CITY OF ALBUQUERQUE

RE: Fast Food Restaurant
Grading and Drainage Plan
Engineer's Stamp Date 2-27-2017 (File: B14D001)

Based upon the information provided in your submittal received 3-6-2017, the above referenced Grading and Drainage Plan cannot be approved for grading permit until the following comments are addressed:

GRADING AND DRAINAGE PLAN

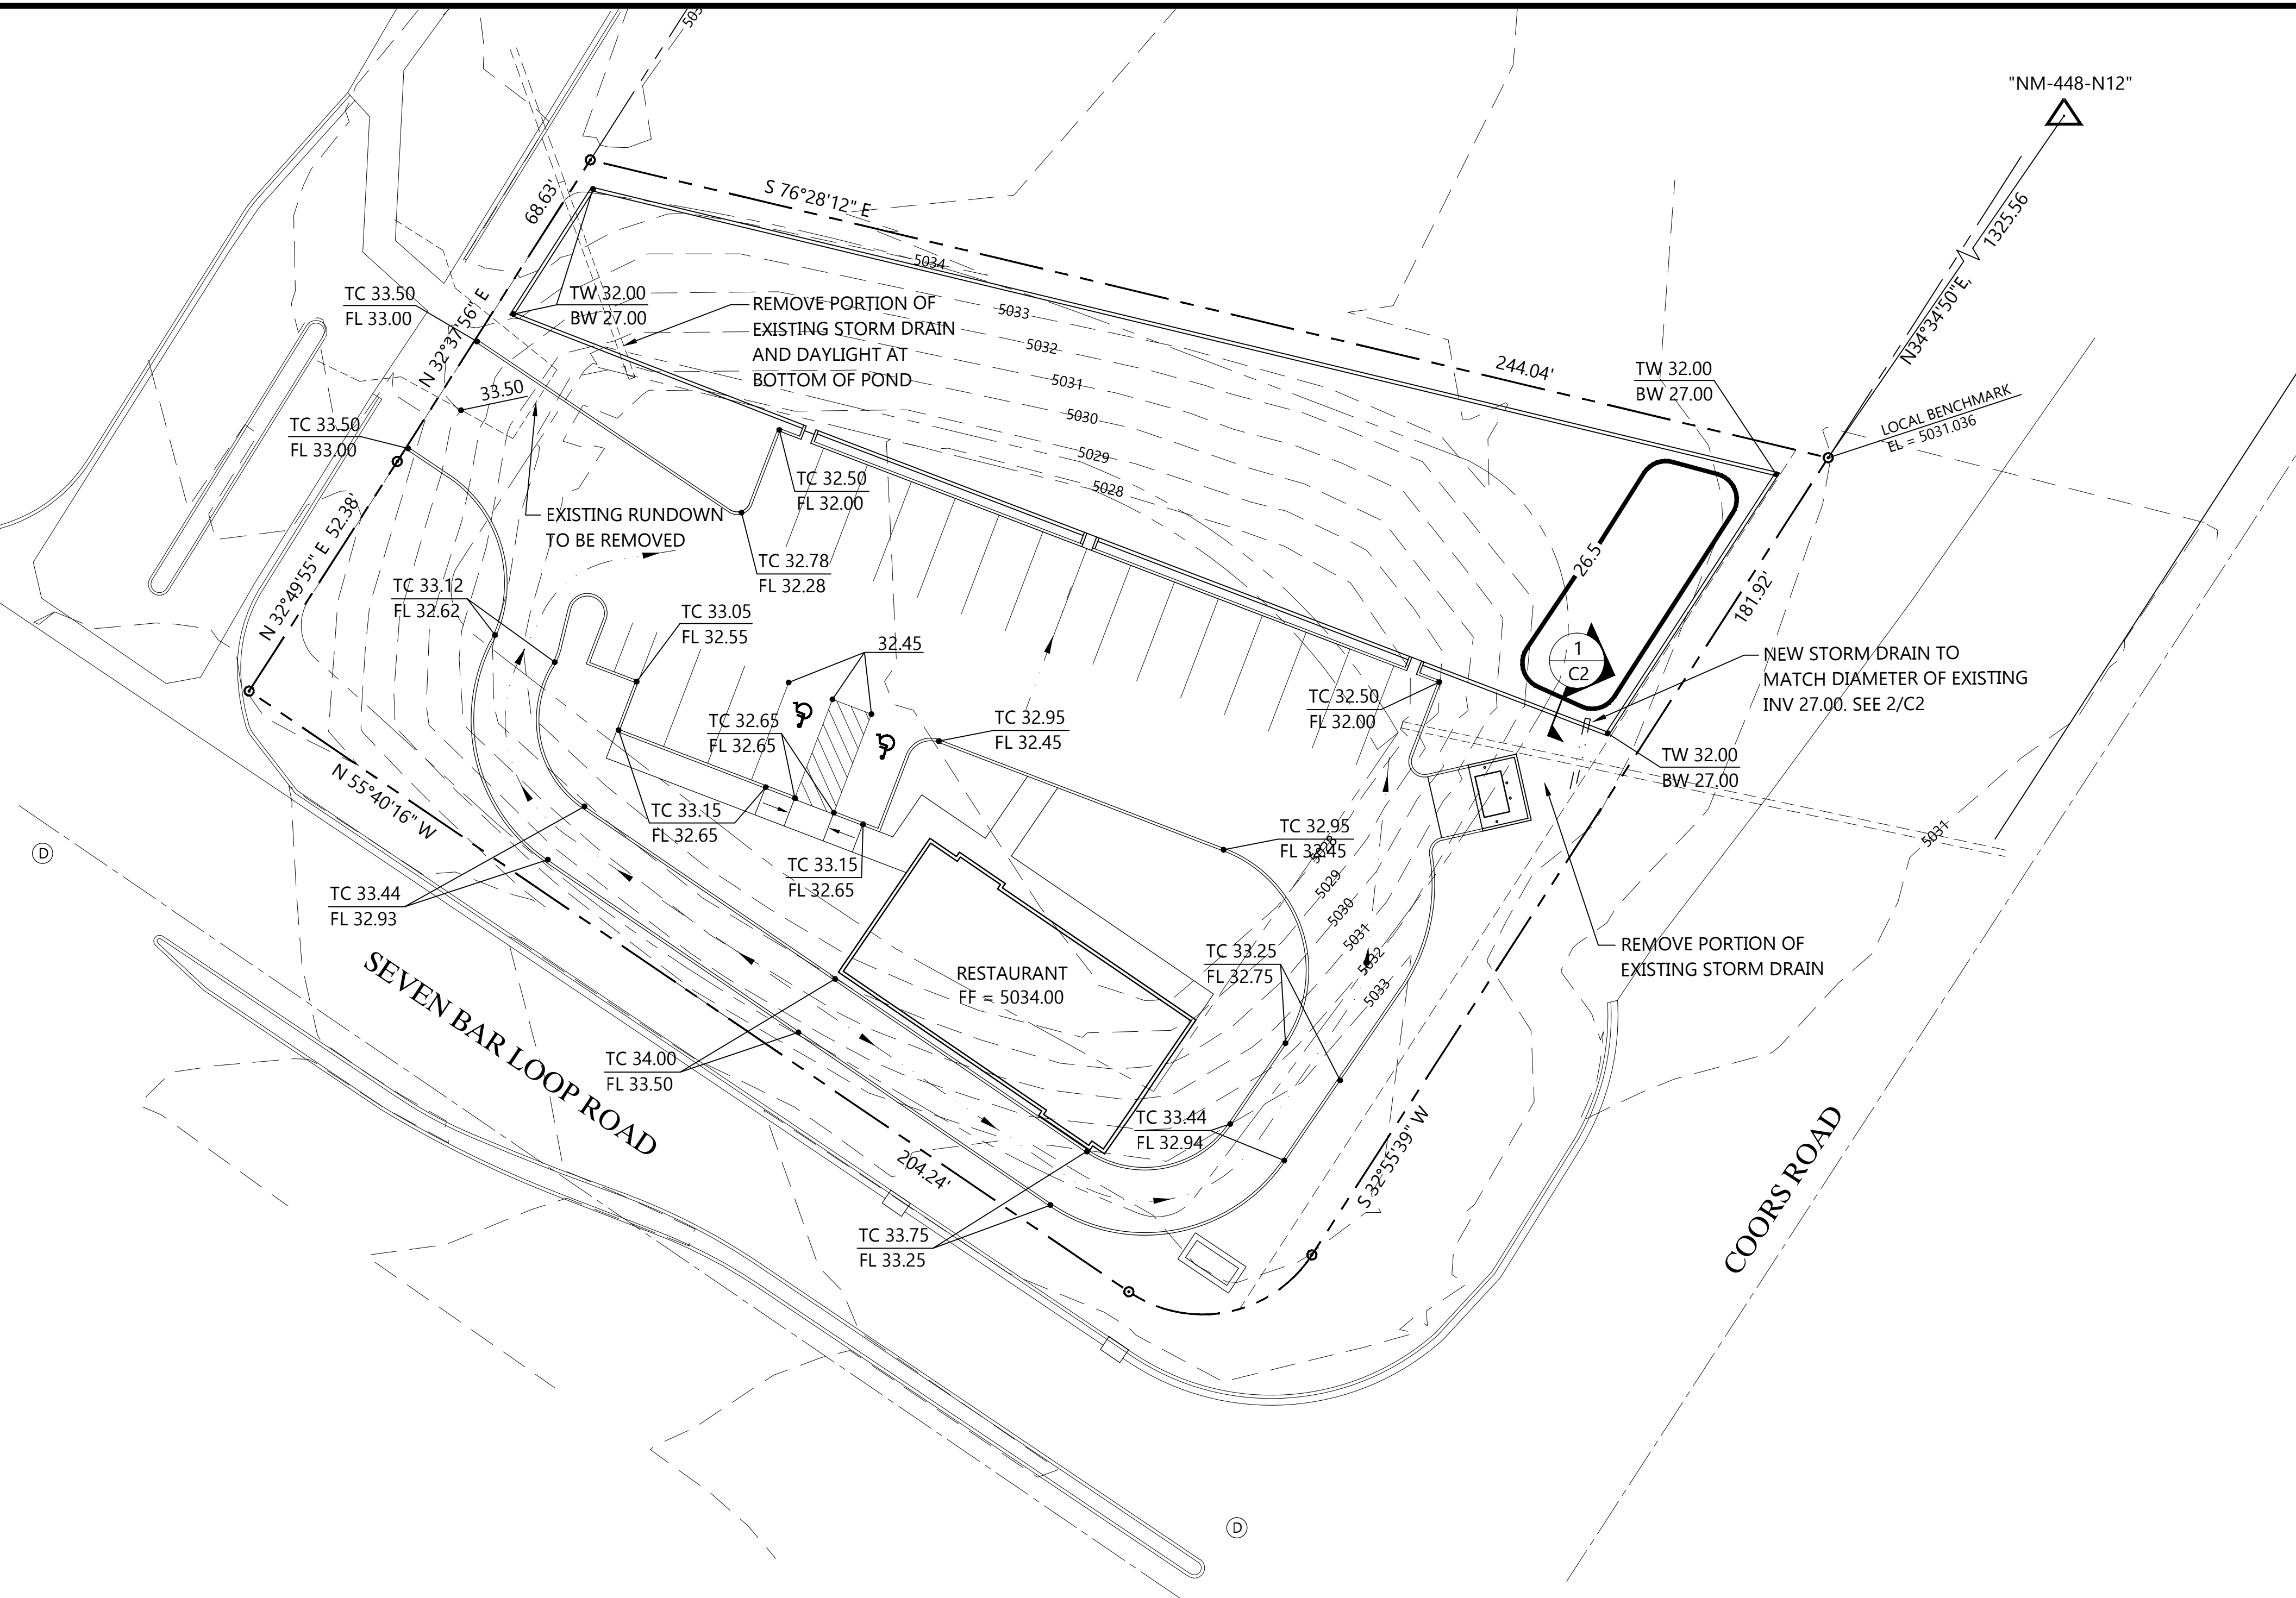
1. Provide details for the trash enclosure to ensure runoff will remain within the enclosure. Included a note that the drain must be connected to a Grease Trap then to the sewer system. Show the location of the Grease Trap and the inverts for the pipe.

2. Provide more details for the new storm drain pipe.
3. Provide roof drain location.
4. Provide more spot elevation along the curb and curb cut on the south side of the pond.

7. Provide size and inverts for the existing storm drain.
8. Not clear how proposed grading is being tied to existing grade along property line.
9. Where is the emergency over flow for the pond?

10. The area at elevation 26.5 and at elevation 27 is the same.
11. Invert for the outgoing pipe is shown at 27.00 on the plan but at 26.7 on calculations the runoff is being retained between 26.5 and 27.00 for the first flush ponding requirements.

POND RETAINING WALL

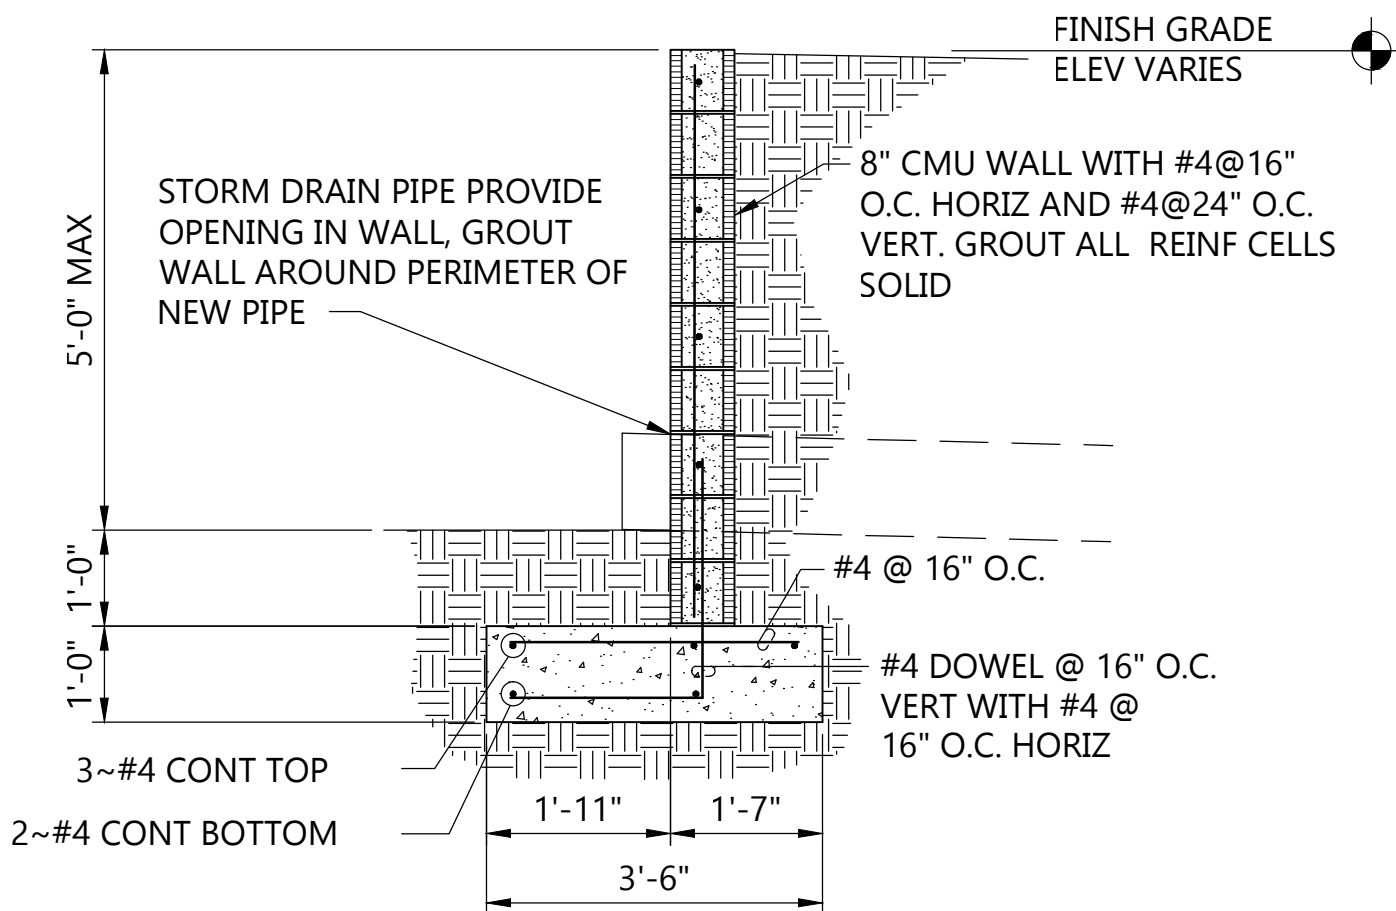
5. Provide more details on the pipe penetration through the wall. Are there any proposed rebar around the pipes?
6. Provide sidewalk grades if proposed / existing along Seven Bar Loop and Coors Road.
